LANDING GEAR - LANDING GEAR WARNING HORN REPLACEMENT

425

441

CQB-32-01
Page 1 of 19

Figure 4. Before Modification (Sheet 1)

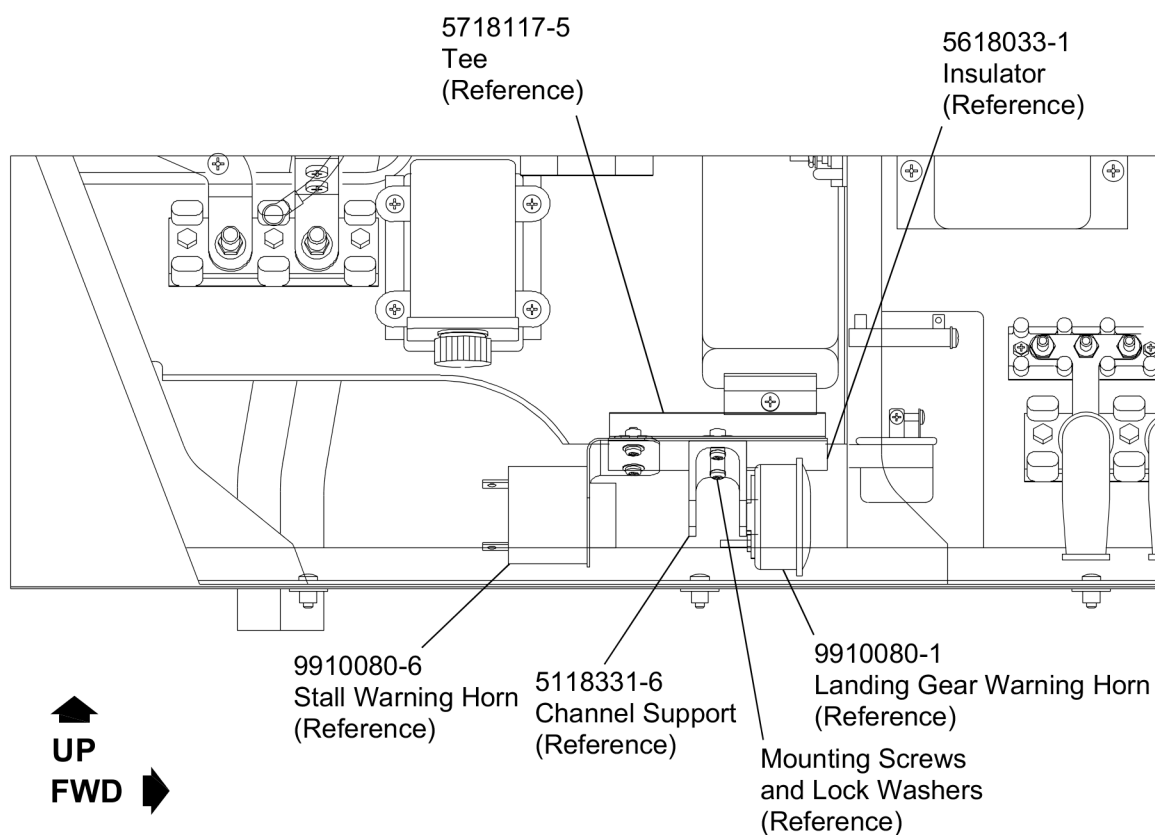
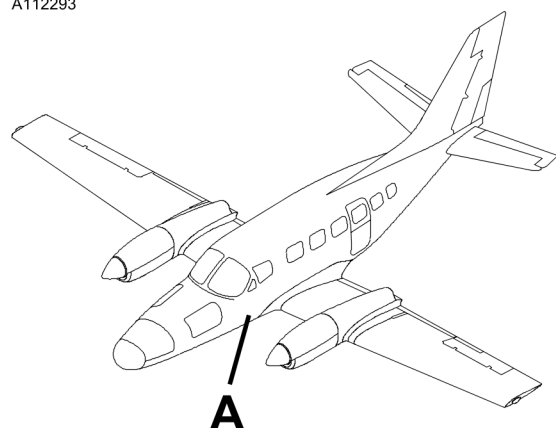
11. (Refer to Figure 4, Sheet 1.) Remove the 9910080-1 Landing Gear Warning Horn as follows:
- A. Disconnect the electrical wiring from the 9910080-1 Landing Gear Warning Horn.
 - B. Remove and discard the screw and lock washer from the 9910080-1 Landing Gear Warning Horn.
 - C. Discard the 9910080-1 Landing Gear Warning Horn.
 - D. Remove and keep the mounting screws from the 5118331-6 Channel Support.

- E. Discard the lock washers and the 5118331-6 Channel Support.
12. (Refer to Figure 5, Sheet 1 and 2.) Install the 9910080-5 Landing Gear Warning Horn as follows:

Figure 5. After Modification (Sheet 1)

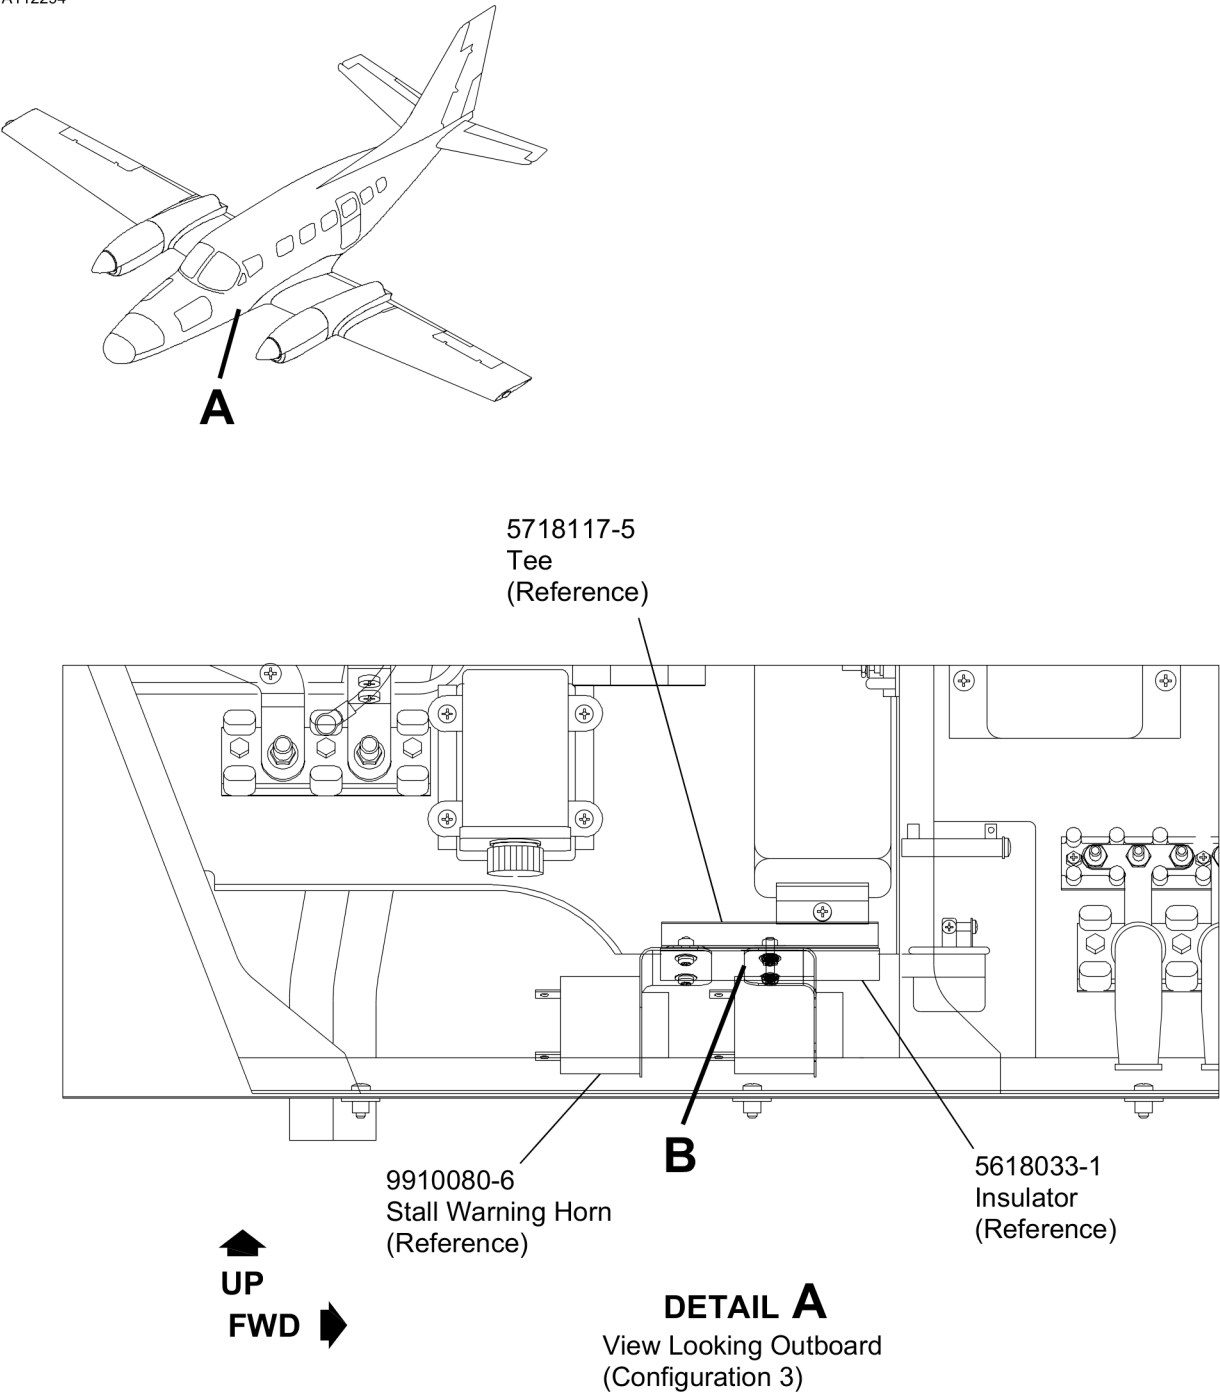
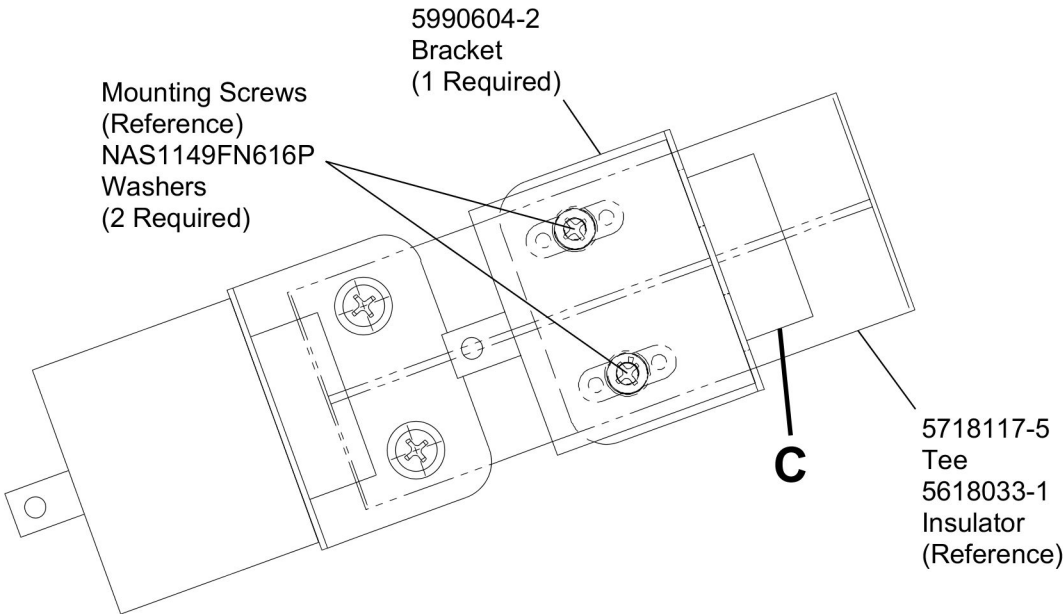
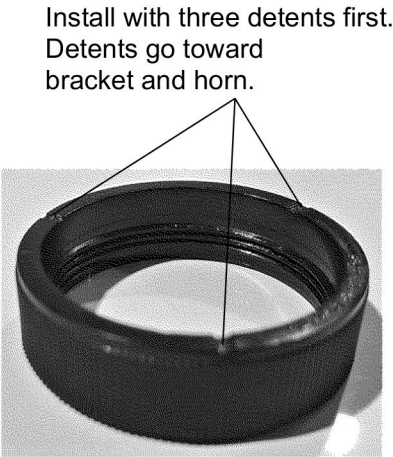
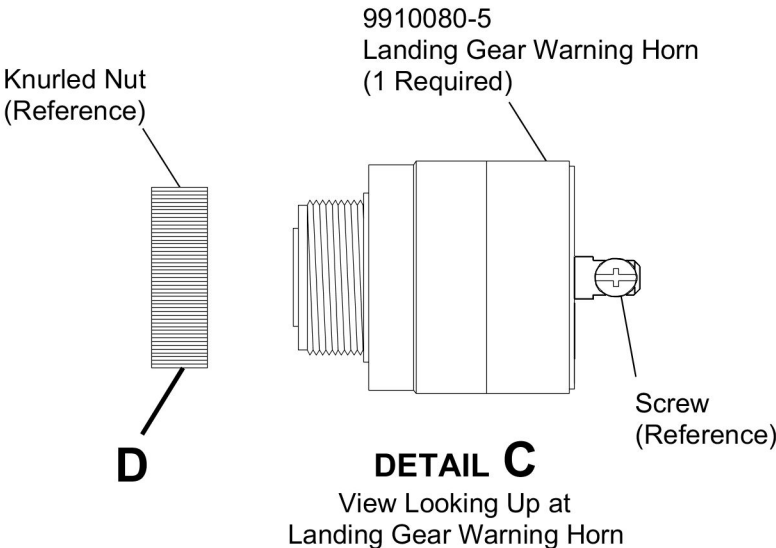
- A. Put the 5990604-2 Bracket onto the existing holes of the 5718117-5 Tee.
- B. Install the two mounting screws with two NAS1149FN616P Washers into the 5990604-2 Bracket.
- C. Install the 9910080-5 Landing Gear Warning Horn into the 5990604-2 Bracket.
- D. Install the knurled nut onto the 9910080-5 Landing Gear Warning Horn.

NOTE: The plastic knurled nut must be installed with the three indents toward the bracket and horn assembly. On the internal circumference, the smooth side without threads is installed first, towards the bracket and horn. This technique of installation will make sure the nut fully seats against the bracket and not bottom-out on the threads. If not installed correctly the knurled nut will bottom-out on the threads and the horn assembly will not be fully tightened to the bracket.

- E. Install the wiring and screws into the 9910080-5 Landing Gear Warning Horn.
